United Wambo Coal Mine Project SSD 7142

Including associated modifications
DA 177-8-2004 Mod 3
DA 305-7-2003 Mod 16

Review Report

26 March 2018

Figure 4: Land ownership and receiver areas, Source: Umwelt, 2018

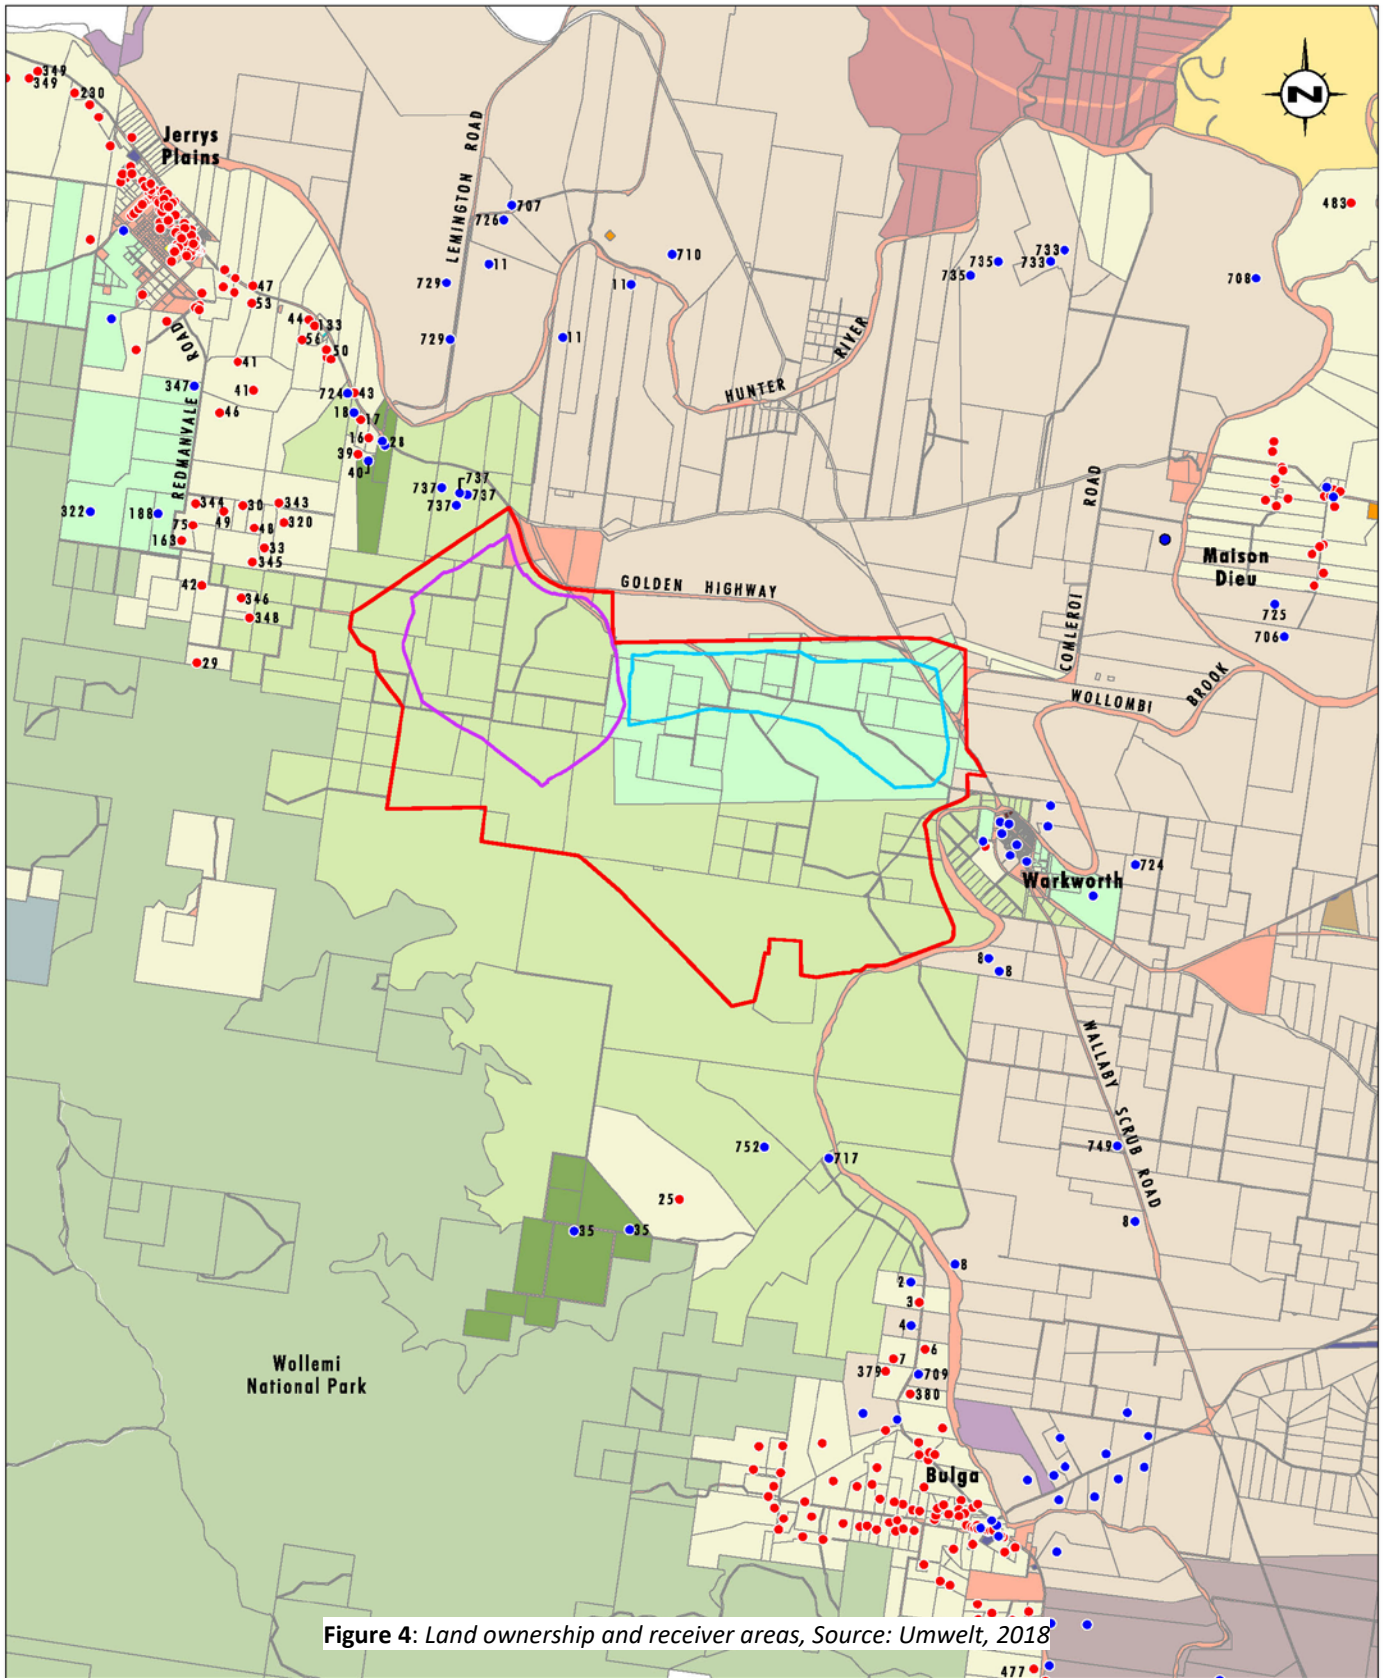
Figure 4 identifies sensitive receiver locations and land ownership surrounding the site. The figure was provided to the Commission on 28 February 2018 with updates identifying recent land acquisitions and secured offset sites.

- R6** The applicant must provide to the Department a revised noise contour map that utilises 1 dB(A) noise contours.
- R7** Based on the revised noise contour mapping, the applicant and the Department must clarify noise impact affectation at sensitive receiver locations. Subject to the outcome of this mapping, the Department should re-assess the application of the VLAMP.
- R8** The applicant shall provide a breakdown of all acquisition rights and mitigation rights for all properties within 3km of the project boundary and the consents under which they are entitled to these rights.
- R9** The applicant and the Department should ensure that any updated noise assessment accurately reflects current land ownership.

Figure 7: Staged mining plans for the project, Source: Umwelt, 2018

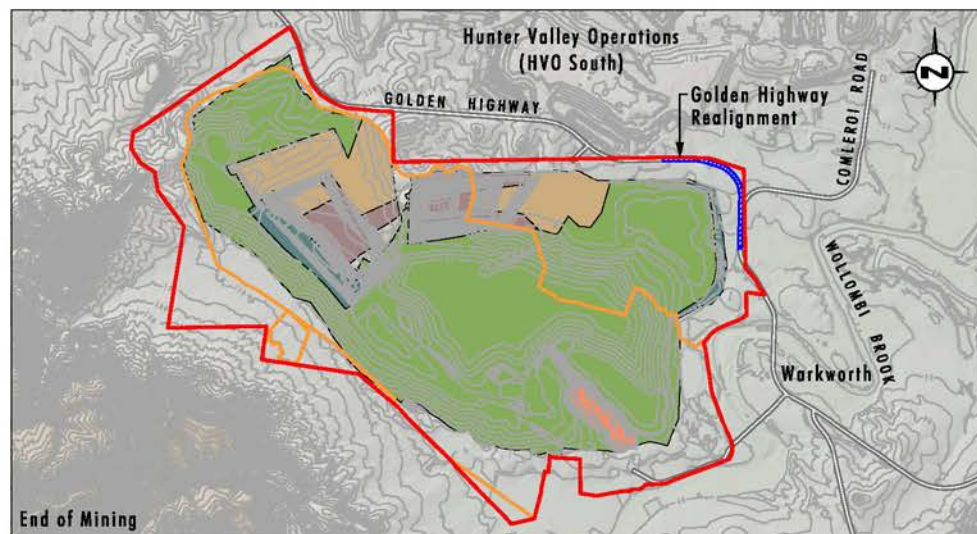
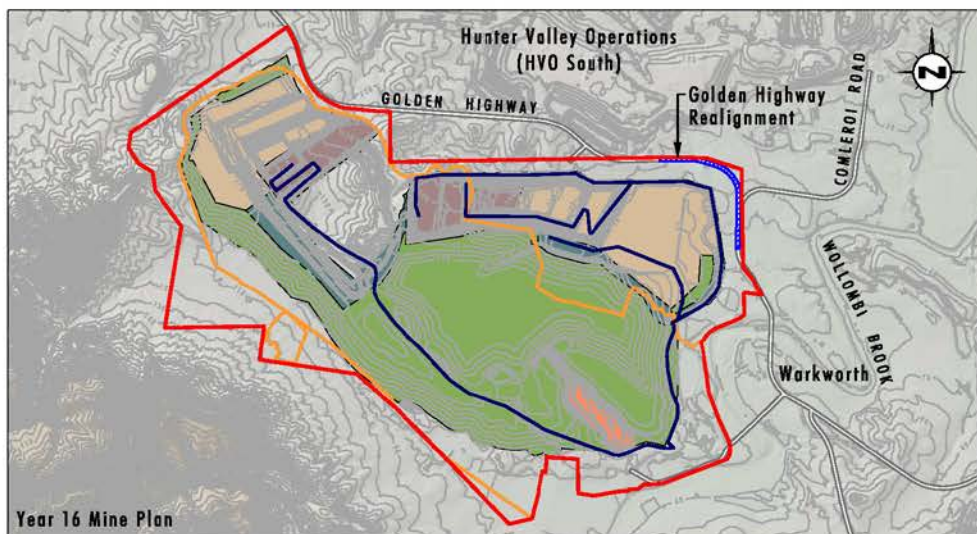
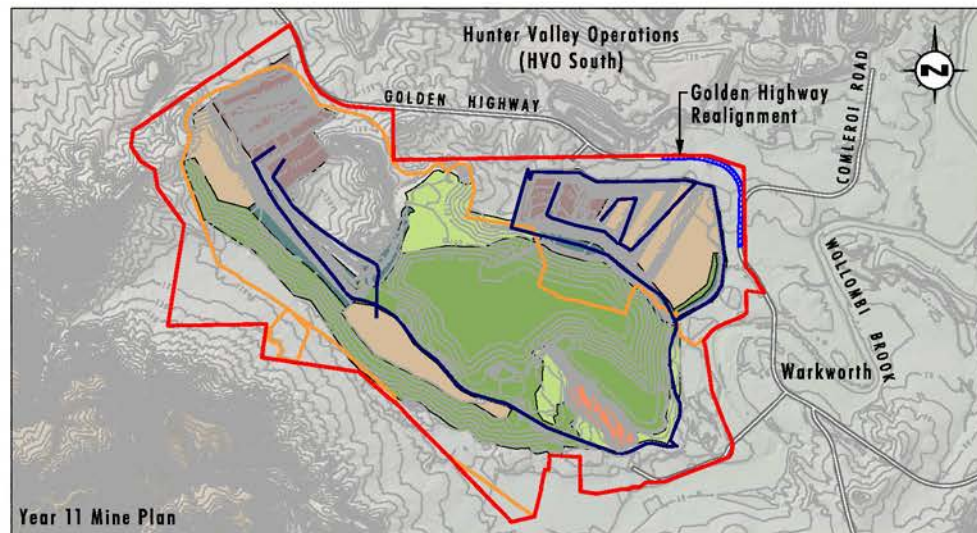
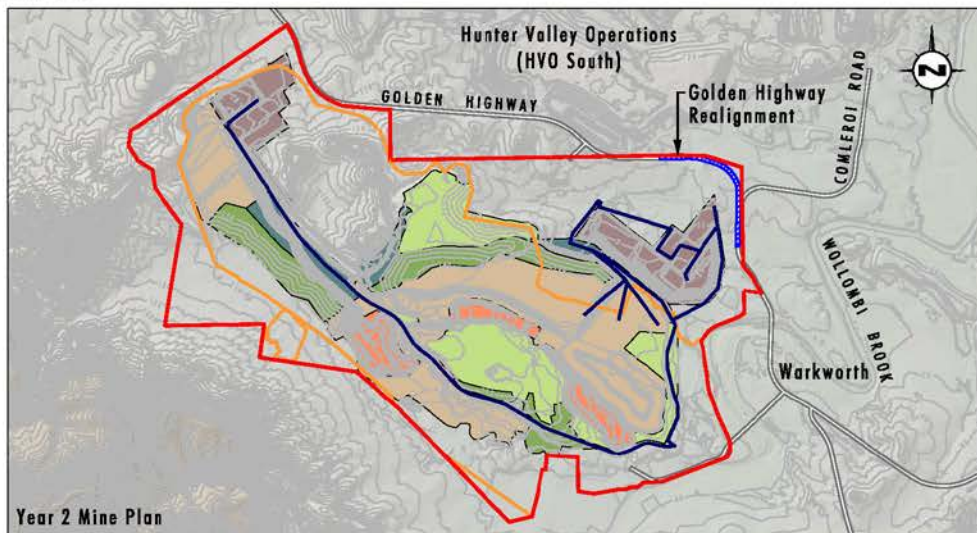
- R24** The applicant must provide further details on project staging accompanied by accurate mapping. The staging must correspond with the project's biodiversity offsetting obligations. The information should include, but not be limited to, a detailed description of each project stage, what it represents and approximate timing, the specific biodiversity offset requirements for each project stage and staging of rehabilitation commitments.

Figure 8: Depth of mining in proposed open cut pits, Source: Umwelt 2018

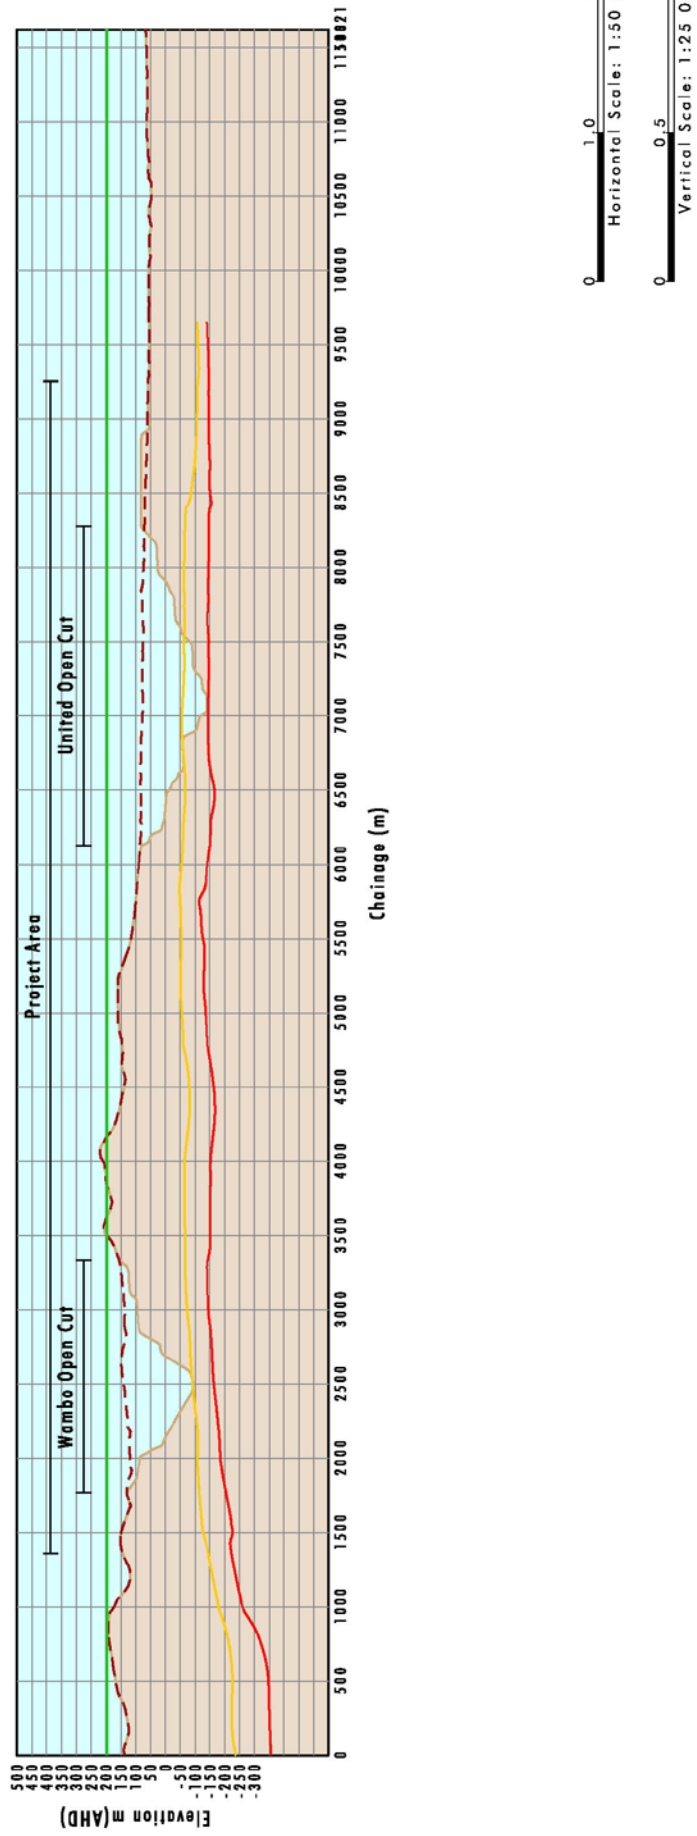
The Commission requested clarification from the applicant regarding final voids and potential for filling voids. The applicant provided the following information in its briefing to the Commission:

Figure 11: Transitional arrangements, Source: Glencore, 2018

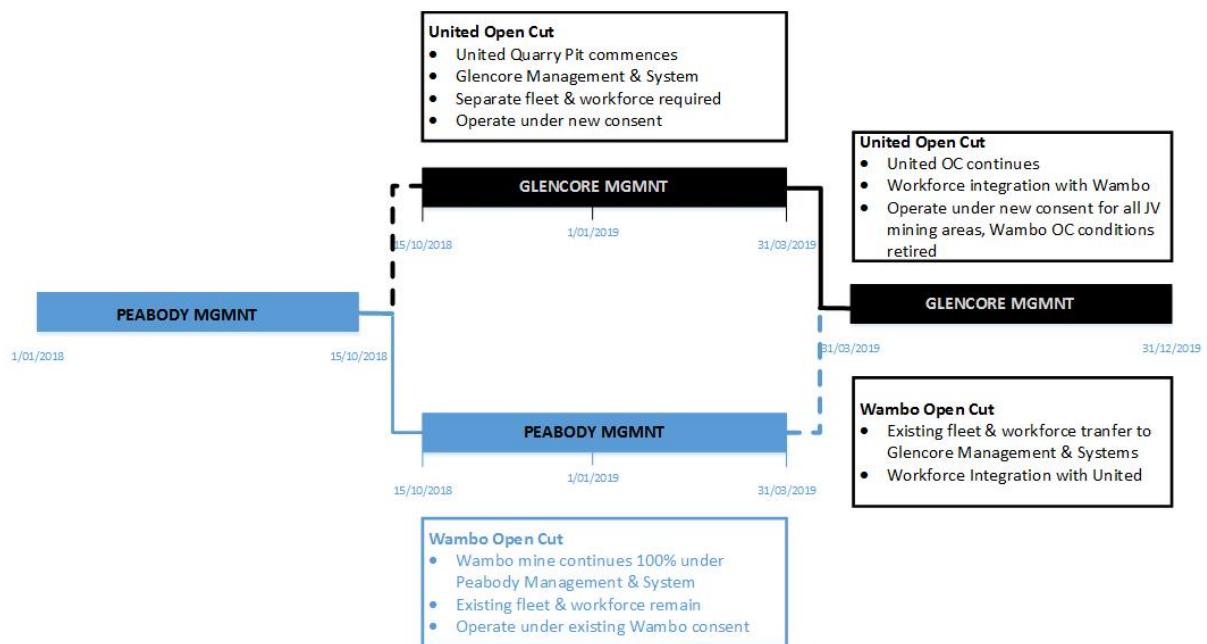
The Commission requested clarification from the applicant regarding the transition to the joint venture. The applicant presented the transitional arrangement in its briefing to the Commission (see **Figure 11**).

R46 The applicant shall provide a summary of the proposed total combined ROM coal outputs of the proposed joint venture open cut operations and the existing Wambo underground operations. Total proposed ROM production shall be reconciled against proposed maximum rail haulage rates.

R47 The Department shall incorporate a clear framework into the draft conditions of consent, to ensure that environmental management is appropriately transitioned from the existing consent to the new consent, should approval be granted.
